SITE PLAN CURRENT PROPOSAL

APPLICATION NO: 02/2018/0065/ PF

PROPOSAL: Erection of a detached dwelling, alterations to the existing vehicular access and associated works (amended scheme to that previously approved under application code no. 02/2015/0995)

LOCATION: Land at (part garden of) Tan Y Gerddi Mwrog Street Ruthin

N PROPOSED SITE LAYOUT PLAN
 1:500

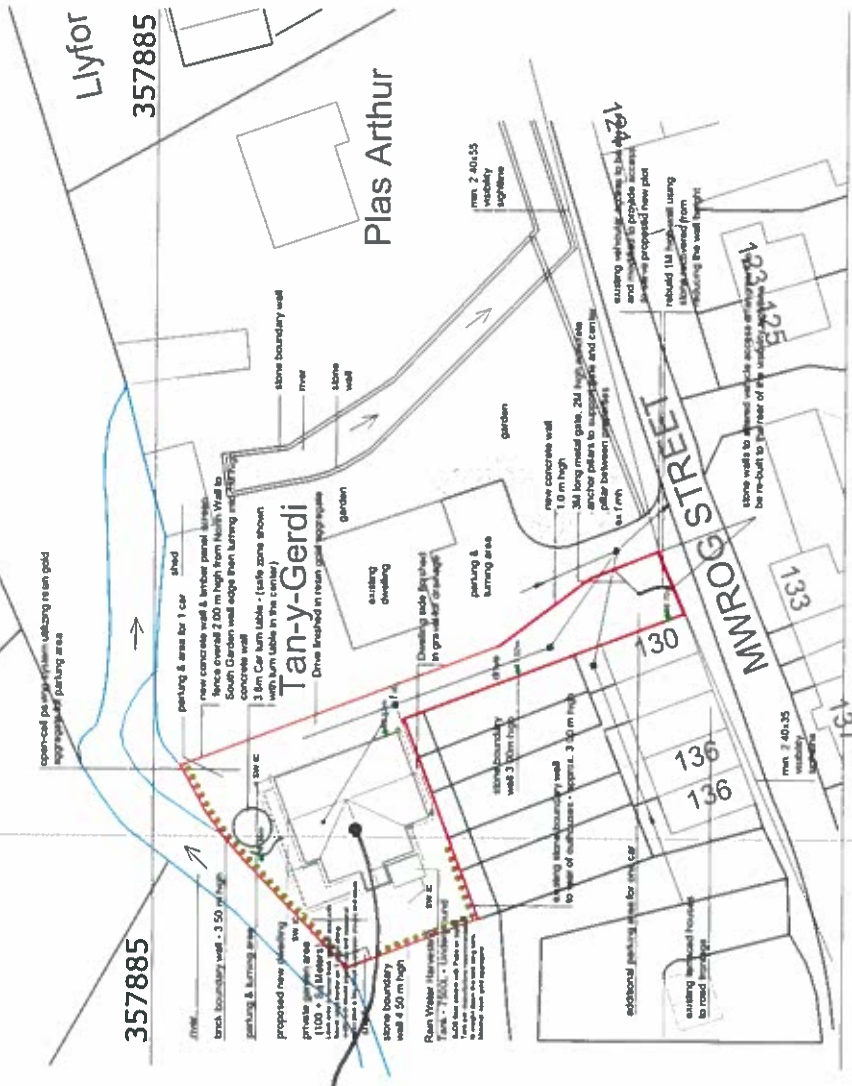
In relation to concerns at overdevelopment of the site, it can be appreciated from perusal of the proposed site plan that the development would leave adequate private space around the dwelling itself so that it would not be unreasonably cramped up against the boundaries of the site or adjacent property. The development would provide well in excess of the 40sq m recommended minimum external amenity space referred to in the Residential Space Standards Supplementary Planning Guidance.

The scheme will utilise the existing access point onto Mwrog Street which currently serves the existing dwelling, with the access widened and improved to allow for it to serve an additional property. It is proposed to erect a curved stone wall at the access point with gates set back.

The property would be served by a driveway and there is space to the rear for vehicles to enter and manoeuvre. A 'car turn table' is also proposed to the rear to ease access in to the integral garage should this be required by the applicant in future.

7. The access shall be laid out and constructed in accordance with the submitted plan before the dwelling is first occupied and shall be retained at all times thereafter.

ELEVATION PLANS

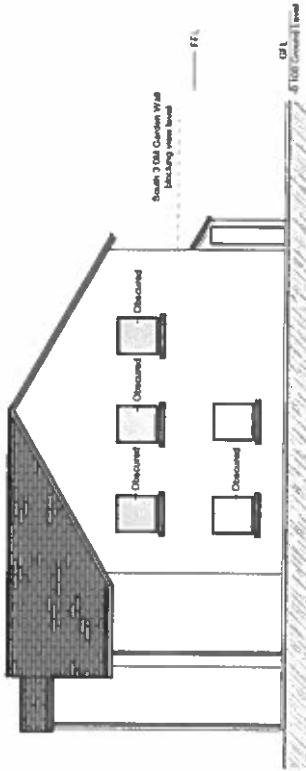
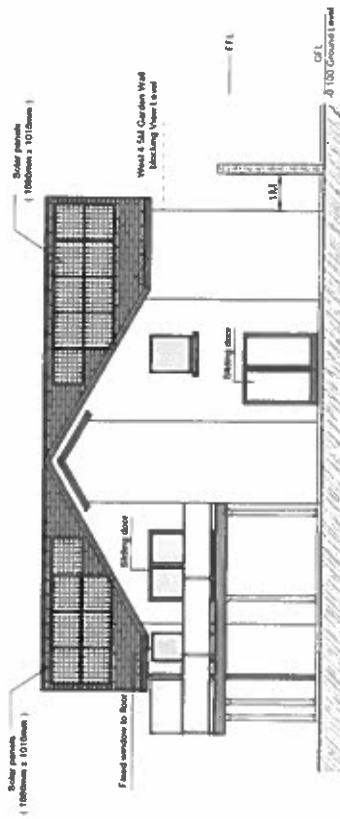
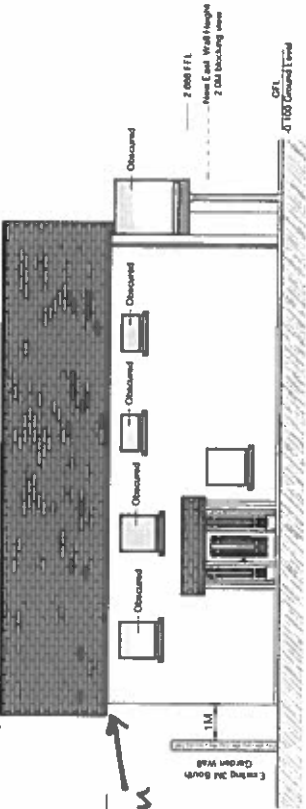
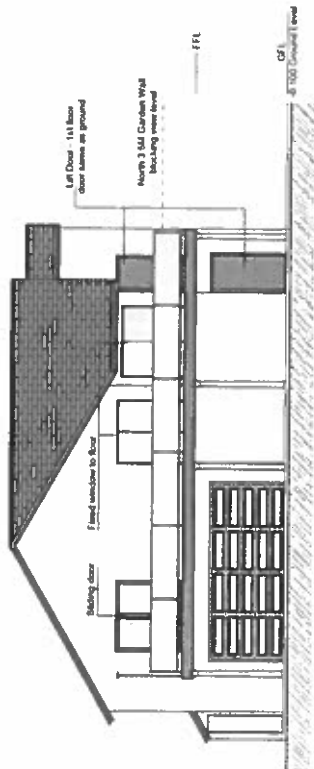
The proposed dwelling would have an eaves height of 4.8m and 7.8m height to the ridge. The height, materials and roof configuration of the proposed dwelling have been amended following the previous refusal (eaves height of 6.5m and 9m height to the ridge) and whilst it is acknowledged that the design is somewhat unconventional, having regard to the location of the site set back off the road, the 3m high wall surrounding the site, the mix of property designs and detailing within the area and overall design approach, overall the proposal is considered acceptable in terms of its visual impact. Notwithstanding this, whilst changes have been made to window detailing, it is still considered this element is capable of improvement and if a

In relation to the dwelling located to the south on Mwrog Street; there would be a bedroom window, bathroom and hallway window at first floor level which are all shown to be obscurely glazed, so there is no overlooking potential from these windows. This elevation is located approximately 21m away from the rear elevation of properties in the terrace, which would be in accordance with SPG guidance and having regard to distance, scale and location of windows, it is not considered there would be any overbearing impact on the residents of these properties. It is suggested that the windows be retained with obscure glazing to avoid any overlooking of private garden space.

In relation to the dwelling located to the west ('Argoed'), this property is located approximately 35m away from the application site boundary. On the west elevation of the proposed dwelling there is a small part of the balcony and a bedroom window however due to the distance in between 'Argoed' and the proposed dwelling and also the orientation of the proposed dwelling it is not considered that there would be any significant adverse effect on the amenities of this property. The boundary brick walls also act as a very effective screen and it is also proposed to landscape the west, north and part of the south boundary.

In relation to the dwelling to the east at 'Tan y Gerddi' this is a single storey property and is the property located closest to the application site. The dwelling has been orientated with its entrance on the east elevation fronting Tan y Gerddi and it is proposed to insert windows at first floor level within this elevation which would serve

a stairway, utility room and the living room. The plans indicate all these windows to be obscure glazed; in relation to the stairway and utility room which are non-habitable rooms this is considered acceptable as they only serve to provide light. In relation to the living/family room, the windows have been included to add interest and are understood to be for visual purposes only as the glazing on the north elevation is the main source of light and aspect for the property and its main living space. Tan y Gerddi does have windows within its western elevation facing the application site, but as the windows at first floor level are intended to be obscure glazed it is not considered that there would be any loss of privacy for this property. A 2m high fence (1m high closer towards the highway) would be erected in between the 2 properties which would act as a solid boundary and effective screen in between the properties.

The balcony on the north elevation would overlook open fields and would have obscurely glazed panels on the eastern corner to ensure there is no loss of privacy for the residents at Tan y Gerddi and therefore would not result in an unacceptable level of overlooking owing to its siting and the screen on the corner.

4. Notwithstanding the submitted plans, the detailing of the proposed windows shall not be as shown, but shall be in accordance with such details as may be submitted to and approved in writing by the Local Planning Authority. The development shall proceed in strict accordance with such approved details.

5. The first floor windows shown on the proposed south and east elevations shall be fitted with obscure glazing, and shall be retained with obscure glazing at all times.

FLOOR PLANS

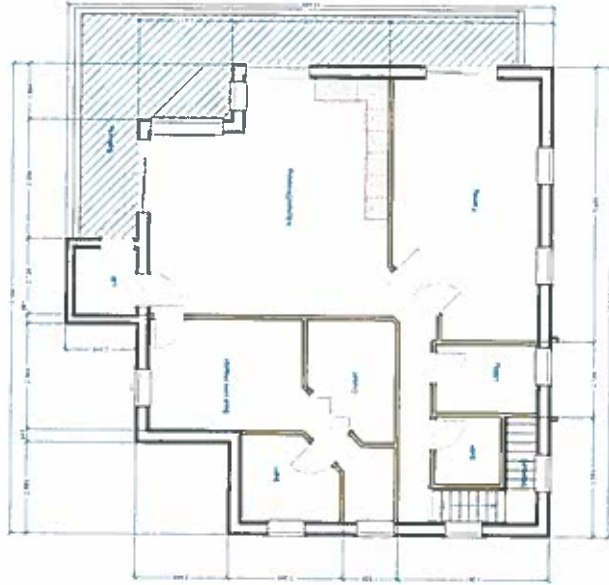
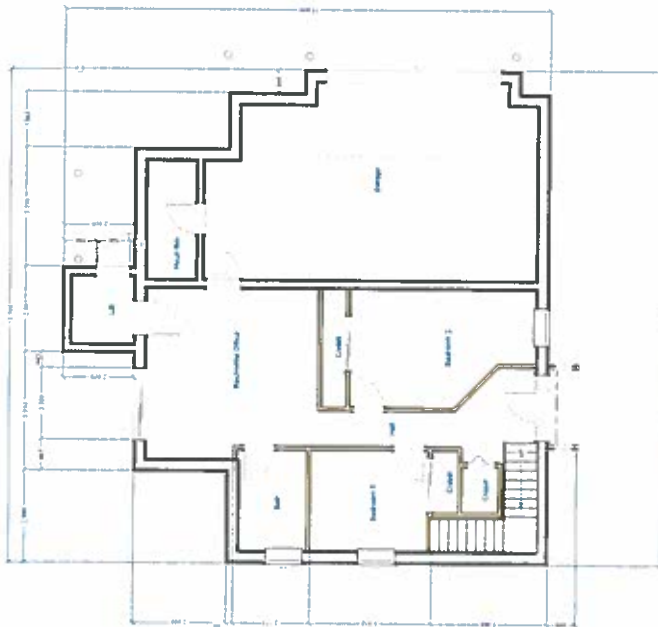
- 1.1.5 The dwelling proposed is a 2 storey unit consisting of an integral garage, an office, 2 bedrooms and bathroom at ground floor level, with a living room, kitchen/diner, bedroom and bathroom/en-suites at first floor level.

The proposed plans show that there would be windows within the first floor of the property facing Mwrog Street, Argoed and Tan y Gerddi.
